Advisory Action
Before the Filing of an Appeal Brief

10/018,469

ALEXANDRE ET AL.

FIG. 3

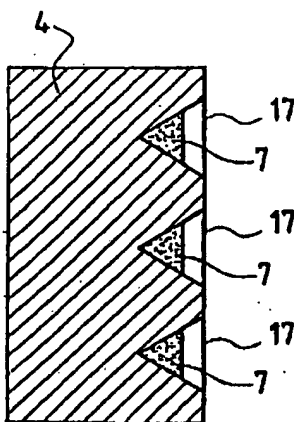
The objection to drawing figure 3 has been withdrawn in light of the remarks in the after final response filed 1/10/07.

Figures 2 and 3 were received on 7/22/04. These drawings are approved.
